La Vergne Planning Commission
May 26, 2026 at 6:00 PM

Planning Commission Report
Meeting: May 26, 2026

Item #: 3. **Site Plan - 1370 Heil Quaker Boulevard - Proposed Truck Parking on 2.51 Acres. Property located at 1370 Heil Quaker Blvd. (Tax Map 17, Parcel 28.01). ID (Interchange District) Zoning District. Property owned by Harsimranjeet Kaur. Requested by Huddleston Steele, Inc.**

SHEET NUMBER:
C-4.1

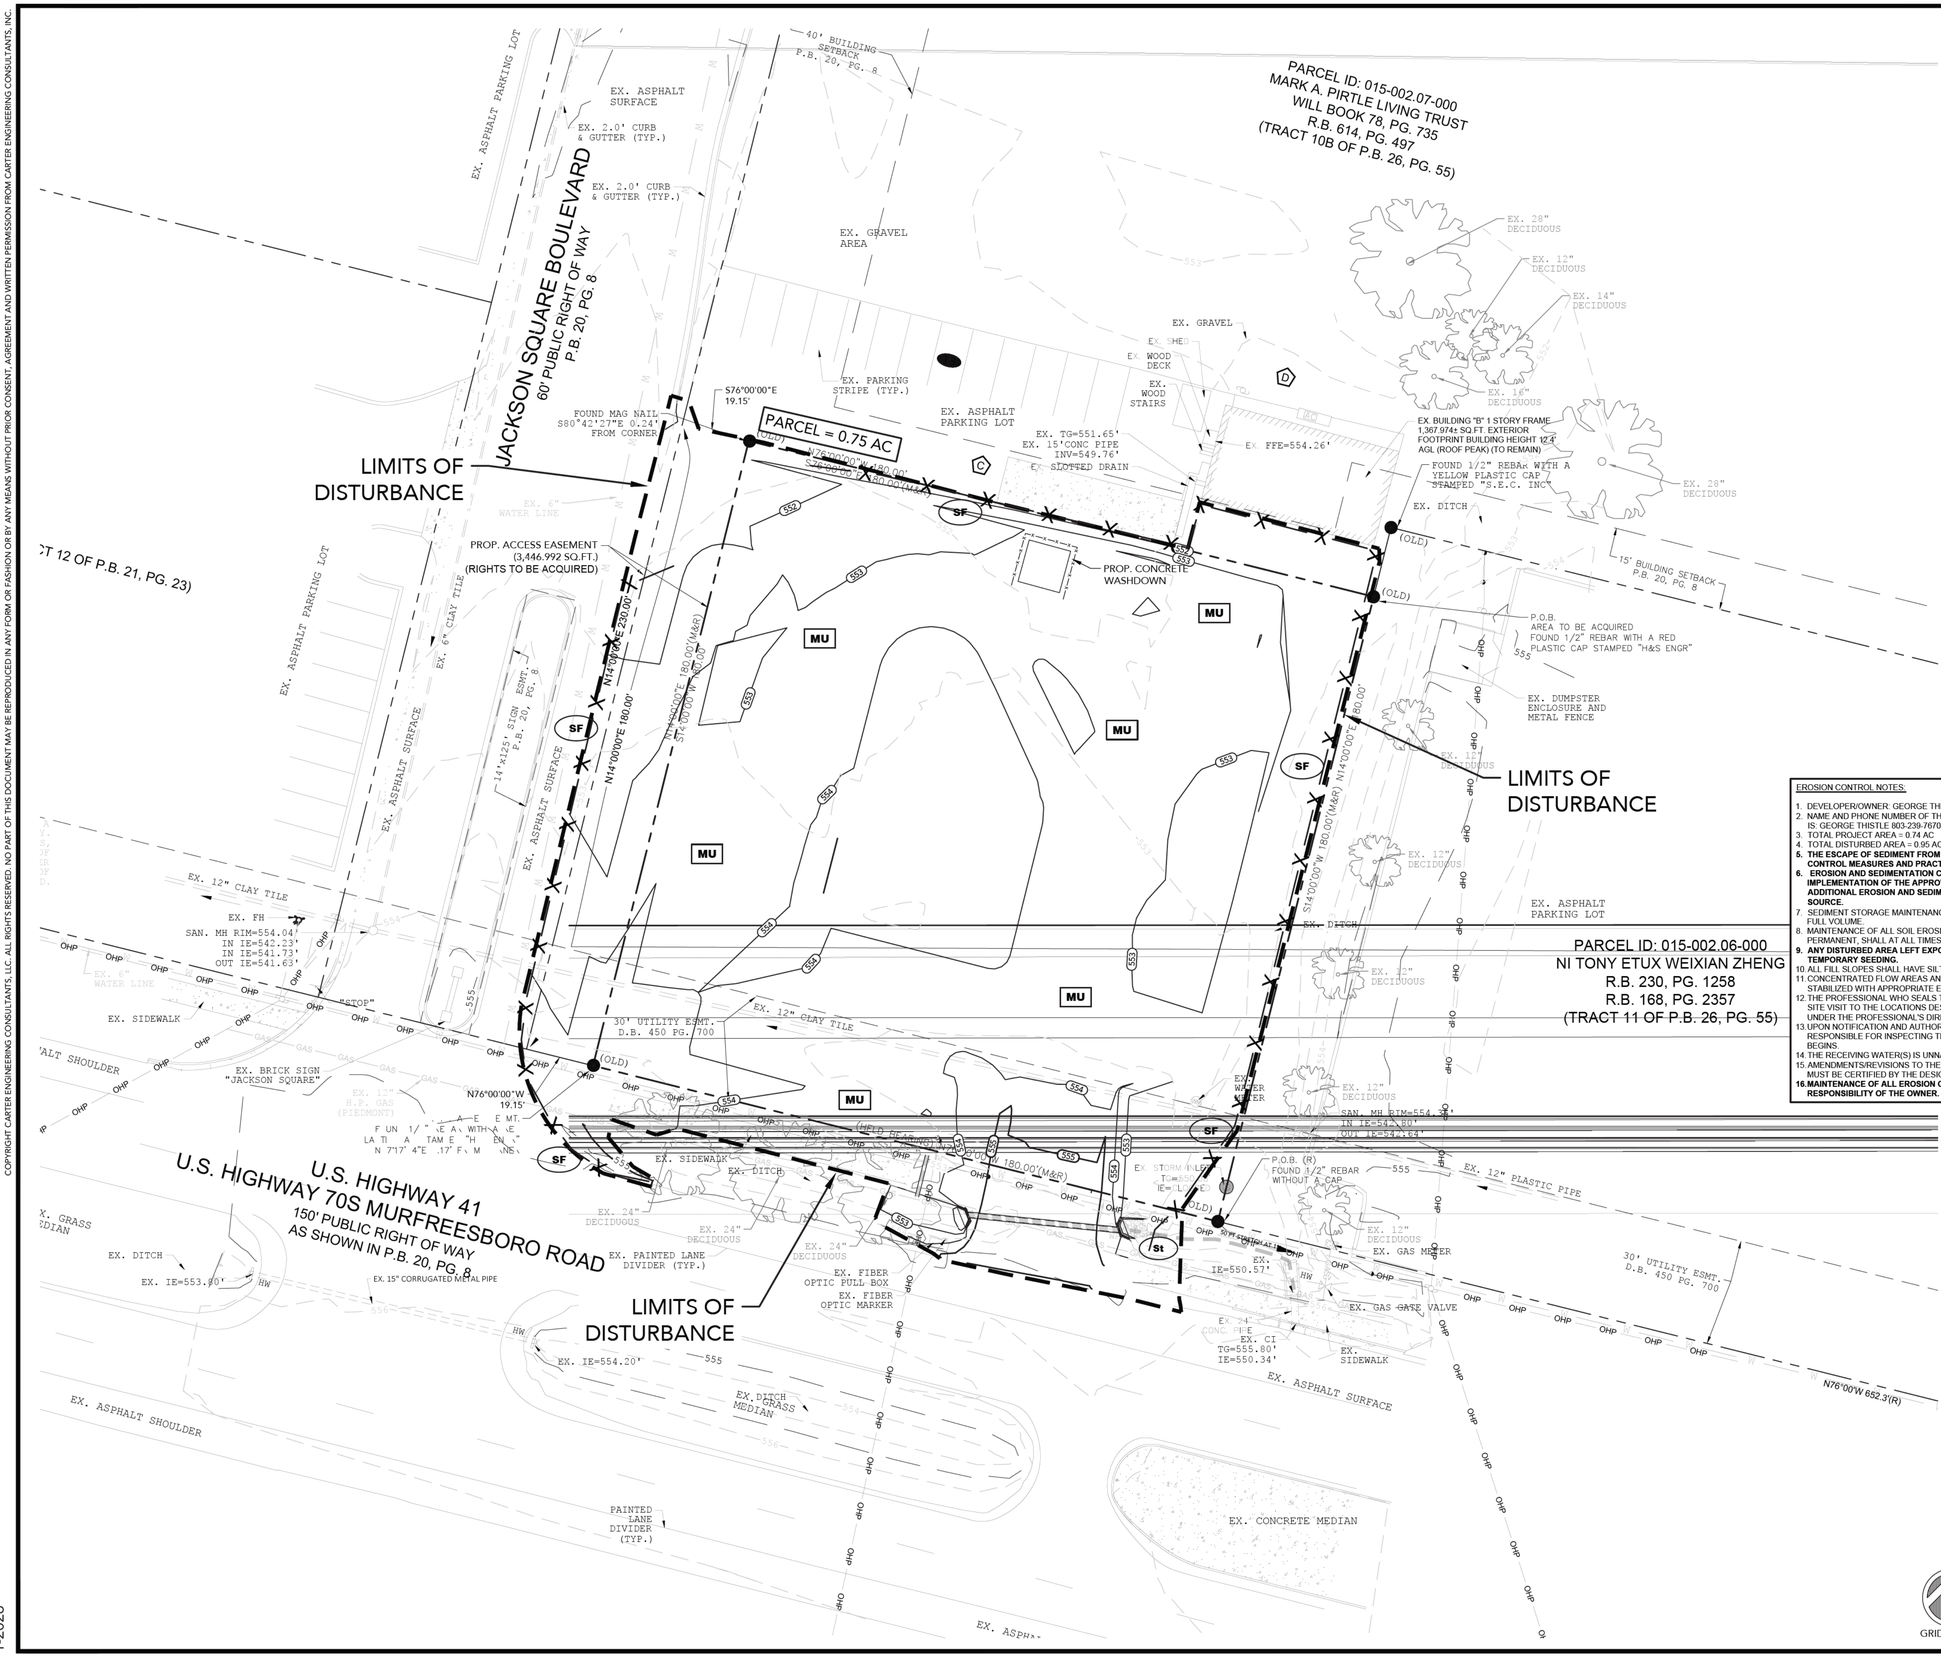
28. (Sheet C-4.1) Provide a check dam completely around the Class 5 Injection Well. Add a note that this will require coordination with the restaurant next door since the well is shown on the property line.

SHEET NUMBER: C-5.0

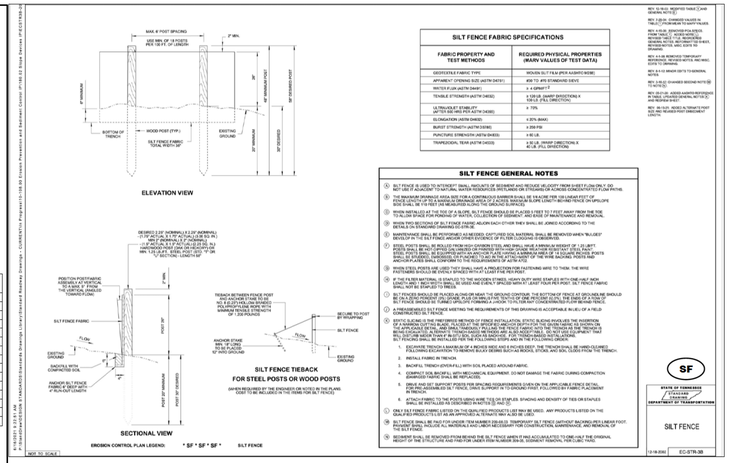
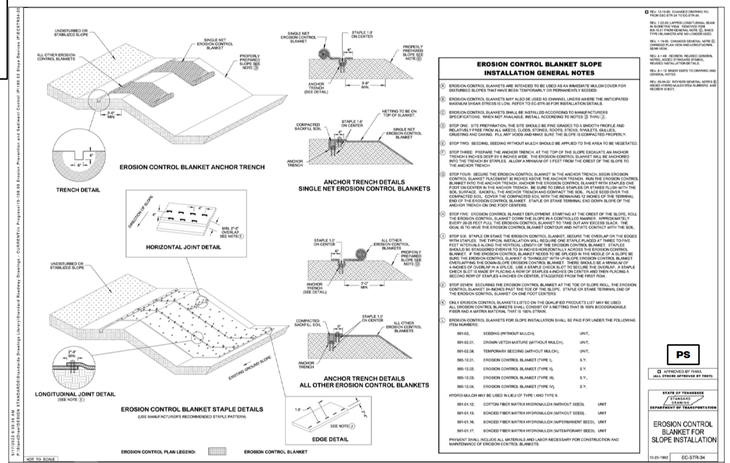
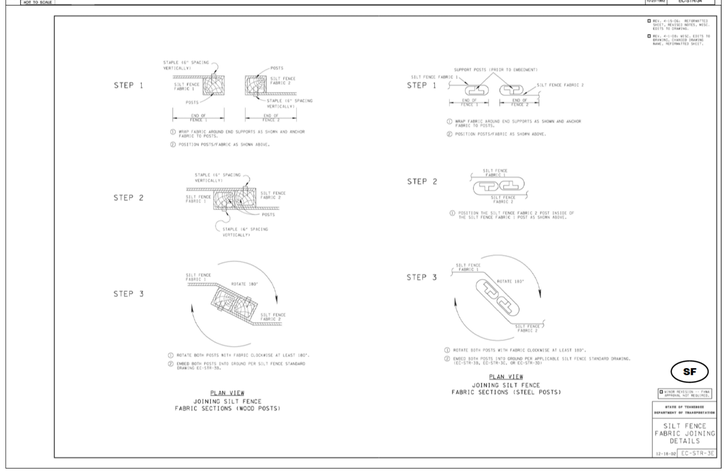
10. (Sheet C-5.0) Make asphalt pavement detail match or exceed City Standard Detail C005. That detail is a minimum. Design engineer remains responsible for ensuring that the section as designed meets the requirements of the project.

c. Curb and gutter on the public section will be 6” post curb and gutter as shown on Standard Detail C010.
12. (Sheet C-5.0) Provide a detail showing how the concrete flumes will go under the public sidewalk

26. (Sheet C-4.0) Call out the ‘OP’ detail from Sheet C-5.0 for the 15” RCP under the drive from Murfreesboro Road.
27. (Sheet C-5.0) Show the temporary construction entrance detail. The city standard is that the travel entrance must be a minimum of 100-feet long. On sites such as this one, engineer may present an alternative such as a pressure washing station at the construction entrance if the 100-foot requirement cannot be met.
